**CERTIFICATE OF APPROPRIATENESS**

**Property:** 836 Fugate, Lot 1, Block 205, Norhill Subdivision. The property includes a historic one-story wood frame single-family resident and a detached garage situated on a 6,136 square foot (59' x 104') corner lot.

**Proposal:** Alteration – Windows and Door

**HAHC Action:** **Approved with Conditions: Approved with the condition that the applicant install a 1-over-1 wood window (to match other windows on the existing structure) in place of the proposed single light fixed window.**

EAST SIDE ELEVATION

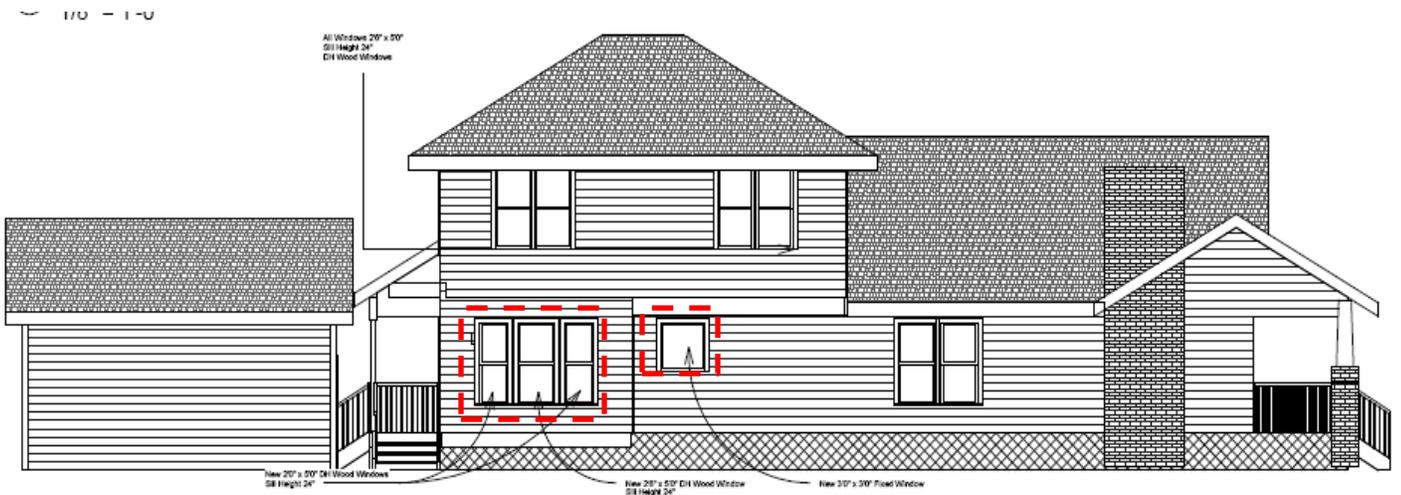
**Recommendation:** **Approval with conditions: Approved with the condition that the applicant install a 1-over-1 wood window (to match other windows on the existing structure) in place of the proposed single light fixed window.**

| <input type="checkbox"/>            | <input checked="" type="checkbox"/> | <input type="checkbox"/>            | (1)                  | The proposed activity must retain and preserve the historical character of the property;<br><i>The original house features all wood 1-over-1 windows and the proposed fixed window on the east elevation does not retain and preserve the historical character of the property</i>  |                            |  |
| <input type="checkbox"/>            | <input checked="" type="checkbox"/> | <input type="checkbox"/>            | (3)                  | The proposed activity must recognize the building, structure, object or site as a product of its own time and avoid alterations that seek to create an earlier or later appearance;<br><i>The original house features all wood 1-over-1 windows and the proposed fixed window on the east elevation seeks a later appearance.</i>   |                            |  |
| <input type="checkbox"/>            | <input checked="" type="checkbox"/> | <input type="checkbox"/>            | (5)                  | The proposed activity must maintain or replicate distinctive stylistic exterior features or examples of skilled craftsmanship that characterize the building, structure, object or site;<br><i>The original house features all wood 1-over-1 windows and the proposed fixed window on the east elevation does not maintain or replicate the style of window that is found throughout the original house.</i>  |                            |  |
| <input type="checkbox"/>            | <input checked="" type="checkbox"/> | <input type="checkbox"/>            | (10)                 | The proposed alteration or addition must be compatible with the massing, size, scale material and character of the property and the context area; and<br><i>The original house features all wood 1-over-1 windows and the proposed fixed window on the east elevation does not maintain the size or character of the original 1-over-1 windows.</i>   |                            |  |
